Rezoning Transportation Analysis

Petition Number: #2022-107

Date	Description
11-28-22	First Review (IW)

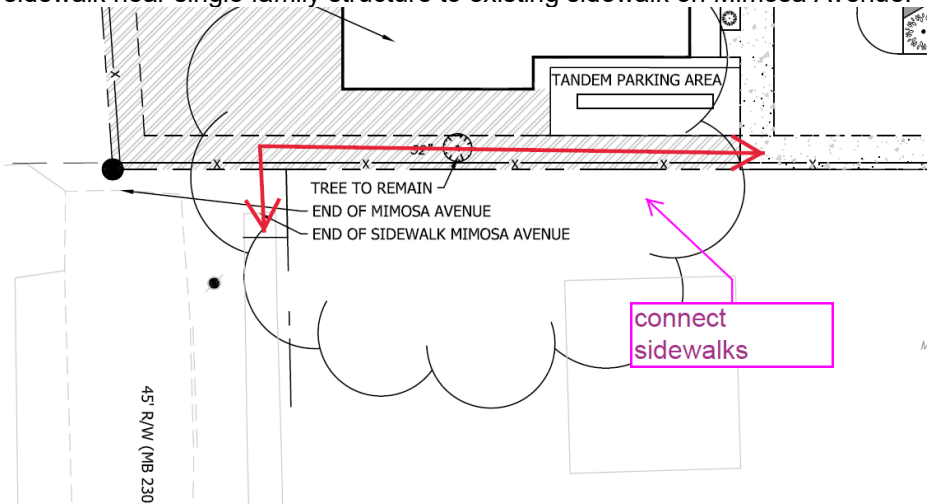
1. **Curbline:** The proposed zoning district has a setback measured from back of the existing or proposed future curblines.
 - a. **Parkwood Avenue:** Location of curb and gutter is 38 feet from centerline.

Label and dimension the curb and gutter from the centerline for each road on the site plan.

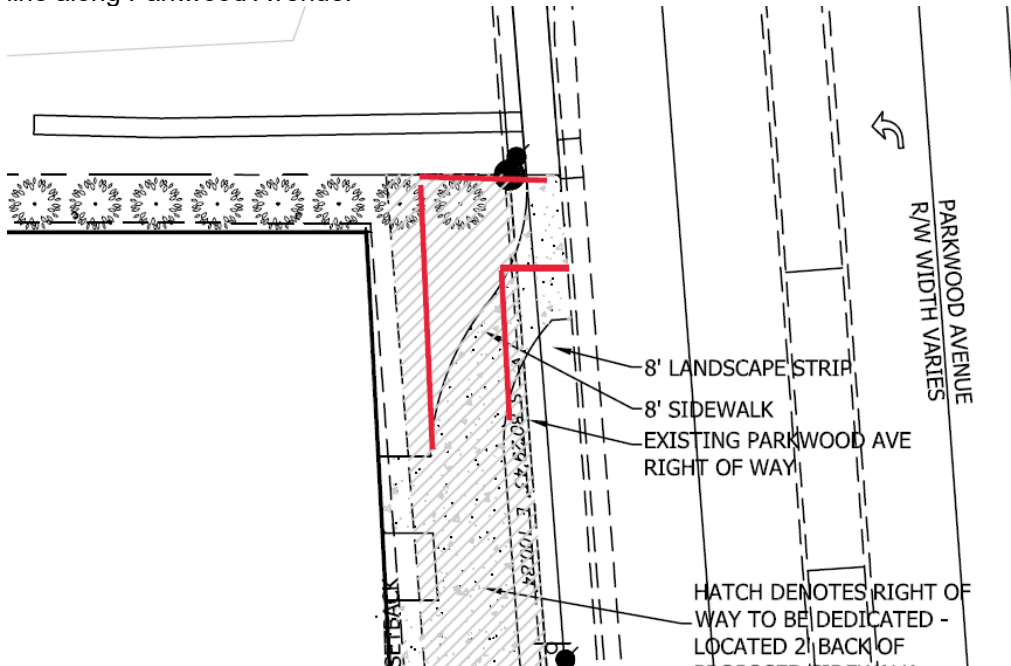
3. Revise site plan and conditional note(s) to commit to dedicate 56 feet of right-of-way from the road centerline. The site plan shall label and dimension the right-of-way from the road centerline.
4. CDOT requests the site plan and conditional note(s) revisions are needed to commit to connect sidewalk near single family structure to existing sidewalk on Mimosa Avenue.
